AMENDMENT OF SOLICITATION/MODIFICATION OF CONTRACT

QUESTIONS AND RESPONSES (#31 – #44)
Refurbishment of Building 2 North and Roof Replacement
of Building 2 North and 2 South

RFP # NNJ06161357R

SKETCH #1

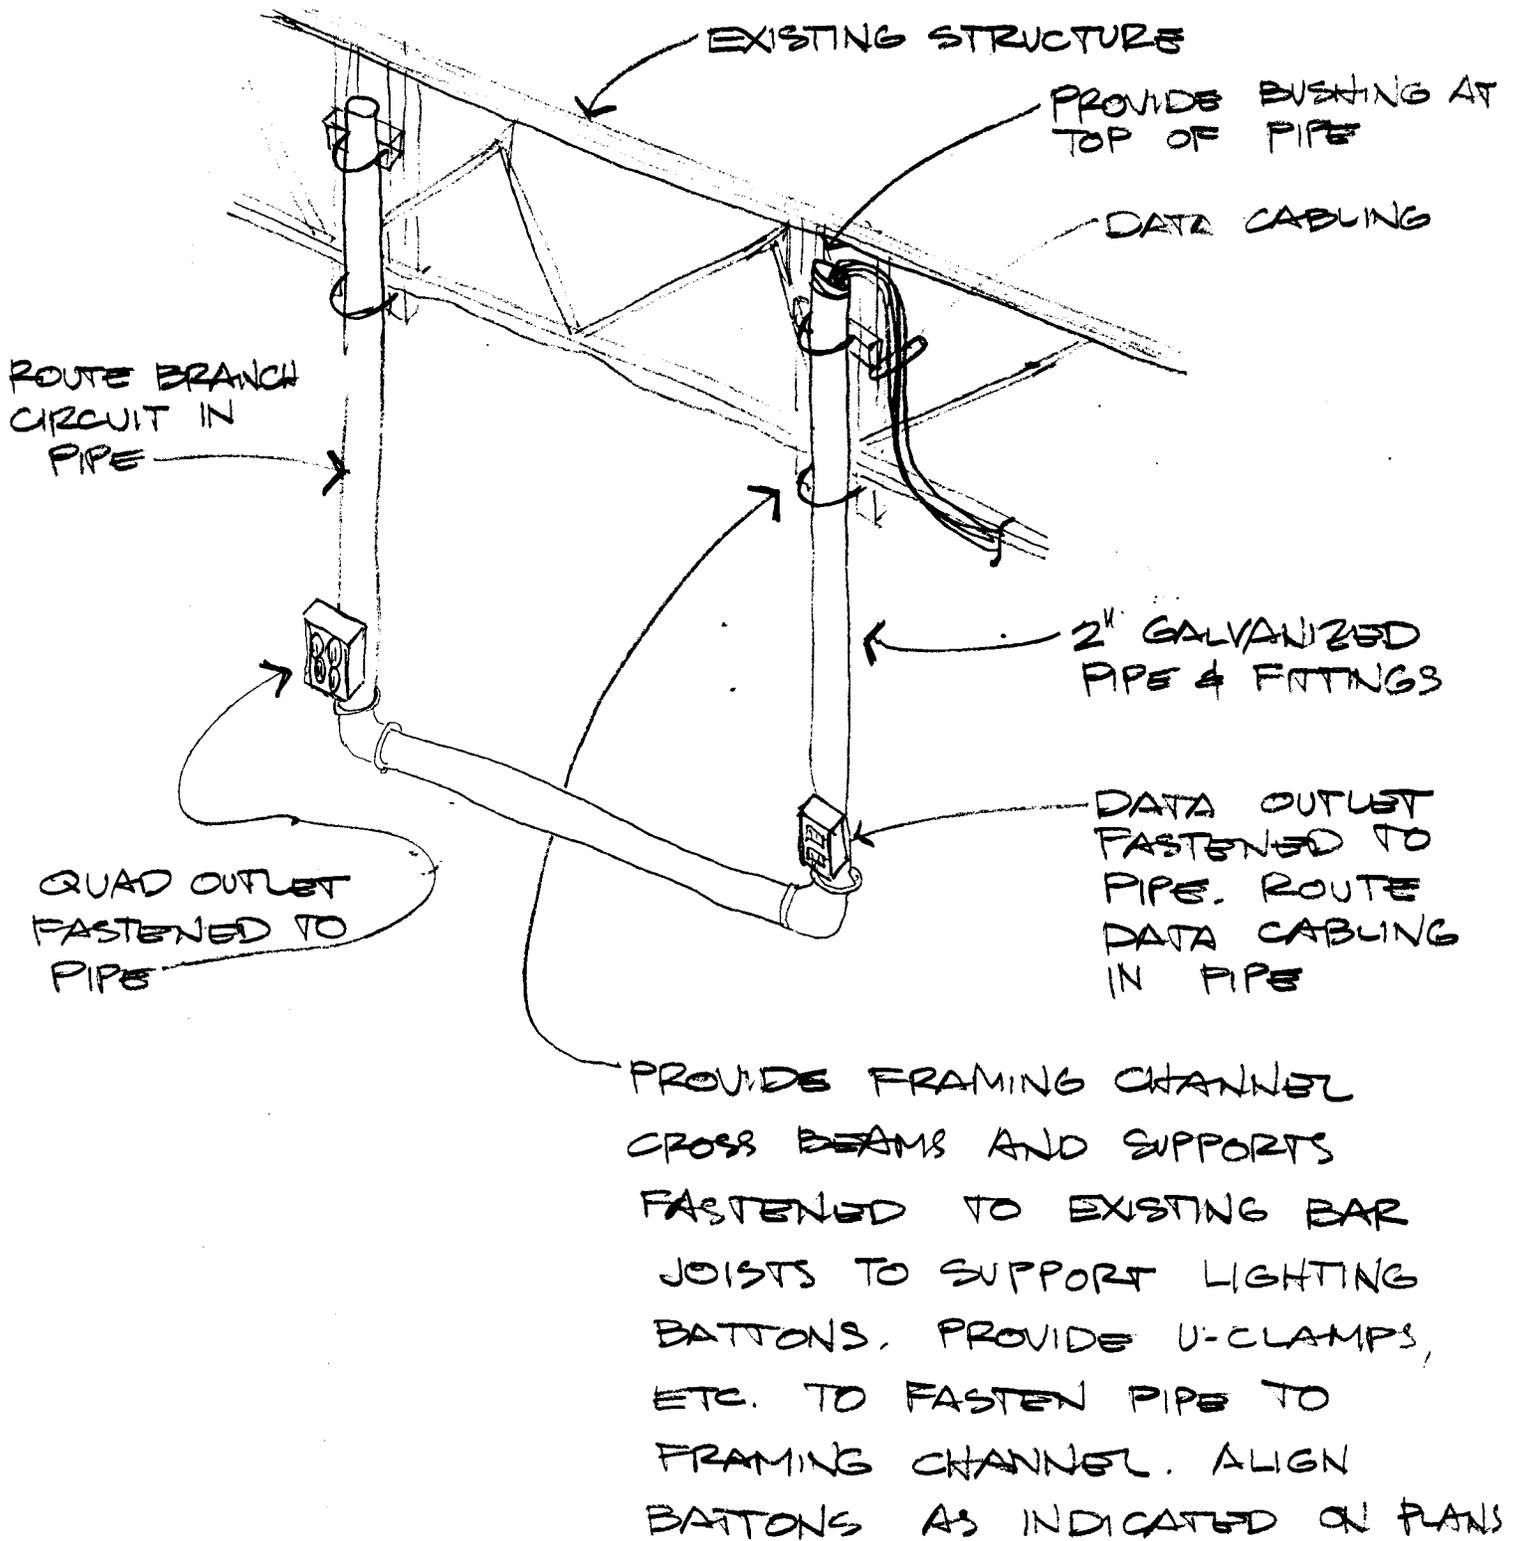
- Question 32:** Drawing E-2N-01 Key Note (3) - Please provide a catalog and support detail for the 2' pipe batons with dedicated circuit and detail of the four category six cable connections to the batons.

- Response 32:** Refer to the attached sketches #1 & #2 for more detail on the batons. The batons are intended to support the stage lighting fixtures that will be provided with c-clamps. A 2" black schedule 40 pipe is acceptable. The quad outlet and data outlet boxes shall both be 2-gang bell boxes.
